SUBJECT: VIRGIL C. SUMMER NUCLEAR STATION, UNIT 1 - STAFF ASSESSMENT OF INFORMATION PROVIDED PURSUANT TO TITLE 10 OF THE *CODE OF FEDERAL REGULATIONS* PART 50, SECTION 50.54(f), SEISMIC HAZARD REEVALUATIONS RELATING TO RECOMMENDATION 2.1 OF THE NEAR-TERM TASK FORCE REVIEW OF INSIGHTS FROM THE FUKUSHIMA DAI-ICHI ACCIDENT (TAC NO. MF3831)

Enclosure:
Staff Assessment of Seismic
Hazard Evaluation and Screening Report

STAFF ASSESSMENT BY THE OFFICE OF NUCLEAR REACTOR REGULATION

VIRGIL C. SUMMER NUCLEAR STATION, UNIT 1

Figure 3.2-1 Plot Comparing the Staff's and the Licensee's Mean Control Point Hazard Curves at a Variety of Frequencies. RAI Response Curves are Licensee Curves Developed Using the Currently Endorsed CEUS-SSC for the VCSNS site

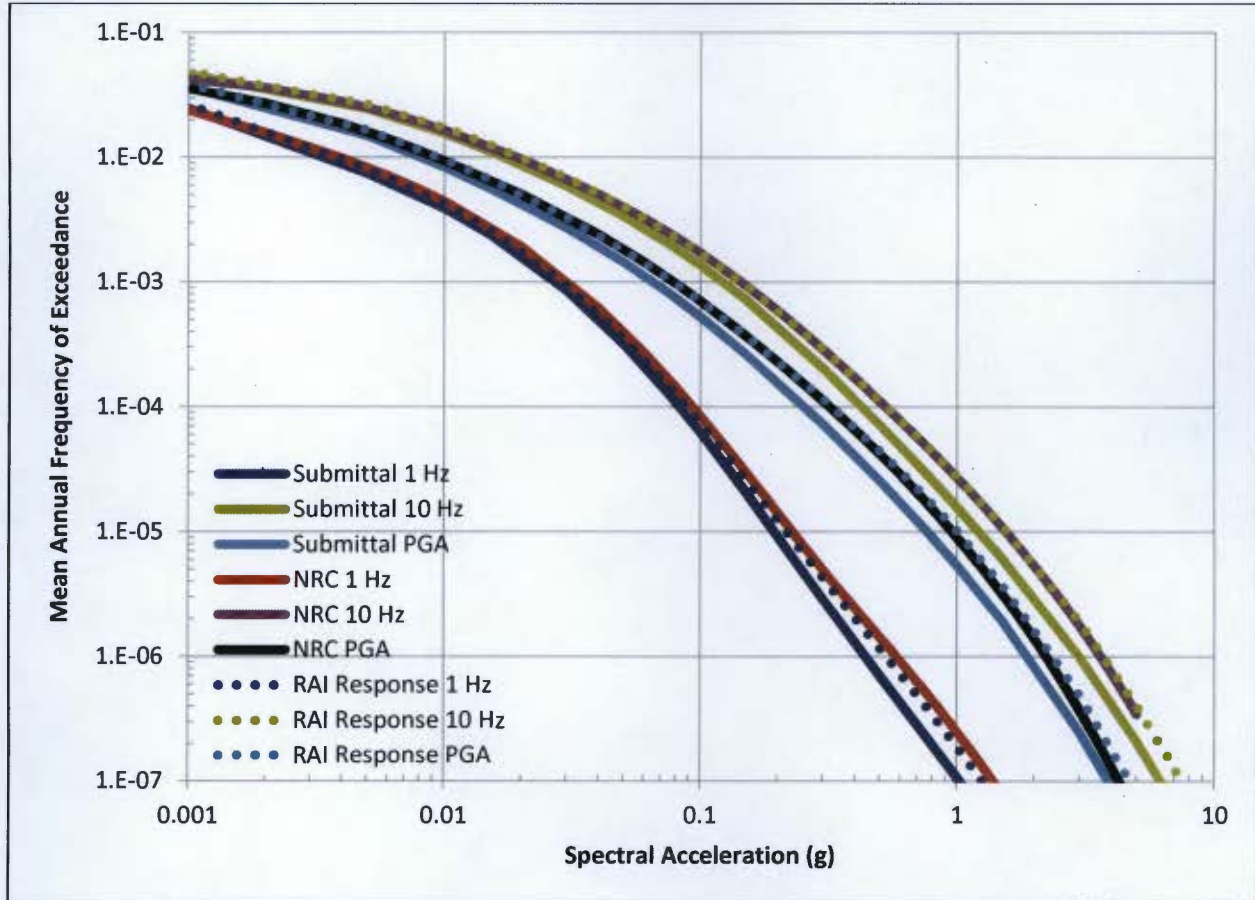
Figure 3.2-1 of this assessment shows the hazard curves developed by the licensee using the modified CEUS-SSC, the hazard curves developed by the licensee using the original CEUS-SSC, and the hazard curves developed by the NRC staff for three of the seven spectral frequencies. The hazard curves developed by the licensee using the original CEUS-SSC model without the catalog revisions are, as expected, the same as the curves developed by the NRC staff. The hazard curves developed by the licensee using the modified CEUS-SSC are consistently lower than those developed using the original CEUS-SSC by about 6 to 16 percent, which indicates that the licensee's revisions to the catalog for the southeastern U.S. had a modest but not insignificant impact.

Figure 3.4-1 Comparison of the Staff's GMRS with Licensee's GMRS and the SSE for the VCSNS site

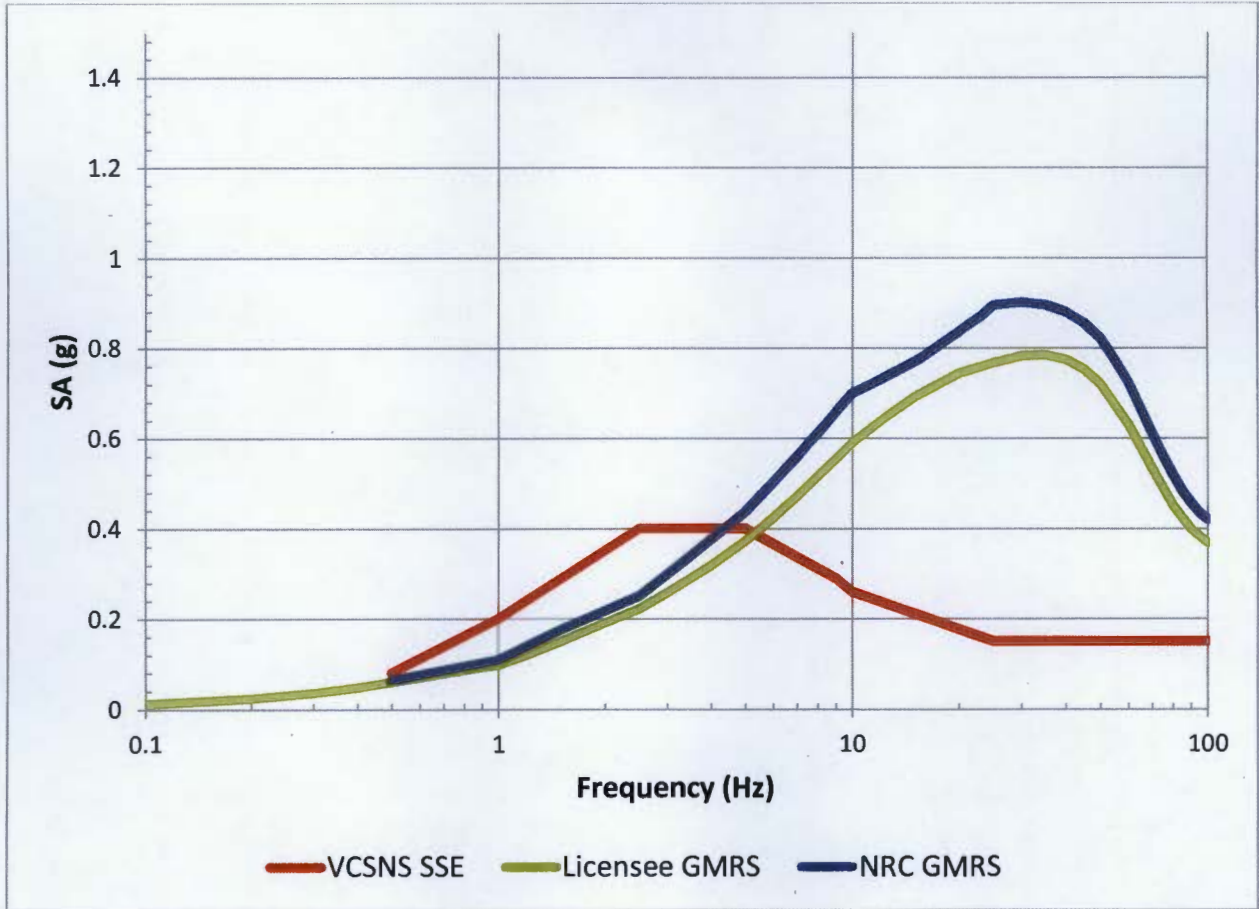
The NRC staff independently calculated the 10^{-4} and 10^{-5} UHRS using the results of its confirmatory PSHA, as described in Section 3.2 of this staff assessment. Figure 3.4-1 of this assessment shows a comparison of the GMRS determined by the licensee to that determined by the NRC staff.

As shown in Figure 3.4-1, the licensee's GMRS shape is generally similar to that calculated by the NRC staff at all frequencies. However, the NRC staff's confirmatory GMRS is slightly higher than the licensee's. As described in Section 3.2, the NRC staff concludes that these differences are due to changes the licensee made to the published CEUS-SSC catalog when conducting the PSHA.

Based on the NRC staff's review of the licensee's SHSR, RAI response and SSHAC report, the staff confirms that the licensee used the present-day guidance and methodology outline in RG 1.208 and the SPID to calculate the horizontal GMRS, as requested in the 50.54(f) letter. The NRC staff performed a PSHA confirmatory analysis and achieved results consistent with the licensee's base rock hazard curves developed with the CEUS-SSC as published. As such, the NRC staff concludes that the GMRS determined by the licensee adequately characterizes the reevaluated hazard for the VCSNS site for the purposes of screening. Because the NRC staff accepted the licensee's SSHAC Level 2 study justifying modifications for the limited purpose of response to the 50.54(f) letter, the staff concludes that the GMRS determined by the licensee adequately characterizes the reevaluated hazard for the VCSNS site. Therefore, this
